**RE: 15 Loma Alta Avenue**

I previously reviewed this project last May, and prepared a review letter with recommendations. I have reviewed the applicant's response to the comments in that letter and their new drawings. In that response letter the applicant drew upon a house in the 200 block of Loma Alta as an example for a design justification. I would remind them that the Town's Residential Design Guidelines clearly define the immediate neighborhood for the primary context within which a project will be evaluated, and explicitly notes that examples at some distance from the site will not be considered.

**Wall material does not match the B & W elevation drawings**

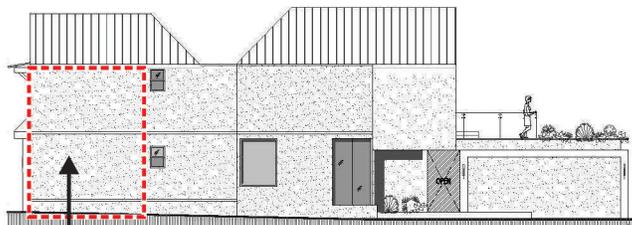
1. The perspective sketch still shows metal panelling on the walls.
2. The roof eave and gable overhangs are still very small.
3. The porch columns are very awkward.

*Change to Stucco*

**Bellybands are too weak to make a difference in apparent wall height**

**Unclear why metal runs down facade and the extent does not match the black and white elevations**

4. It is unclear why a metal strip appears to be run down the corners of some walls. In any event, there are conflicts among the drawings as to the extent of the metal strips.
5. Bellybands have been added to break up tall walls, but they are too weak to make a visual difference in the apparent wall height, and are not robust enough to satisfy the intent of the Residential Design Guidelines.
6. The tall two-story wall on the right side elevation is very blank, and the front portion will be seen from the street and sidewalk.

1. Update and coordinate the drawings to show stucco rather than metal panels on all walls of the house.
2. Extend eave and gable overhangs more, and add wall caps at the flat roof portions of the house.
3. Simplify the porch columns and eliminate the center support.
4. Resolve the issue of the metal strips shown at some building corners. Smooth stucco corners would be the preferred solution.
5. Provide more substantial bellybands.
6. Add windows to the tall walls on the right side elevation.
7. Resolve the issue of recessing the garage door.

**This blank two-story wall will be visible from street and sidewalk**

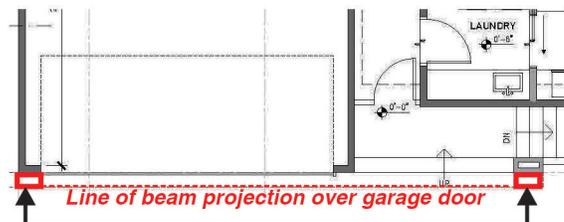
7. The applicant stated in their response letter that the garage door had been recessed by one foot, but the drawings do not clearly show that - see illustration below. The general solution of a projecting frame at the edges and over the garage door shown on the perspective sketch could work, but would require additional encroachment into the side setback or moving the garage back from the side street.

**Surround supports would need to be here to satisfy garage inset recommendation**  
*This would require more encroachment into the setback*
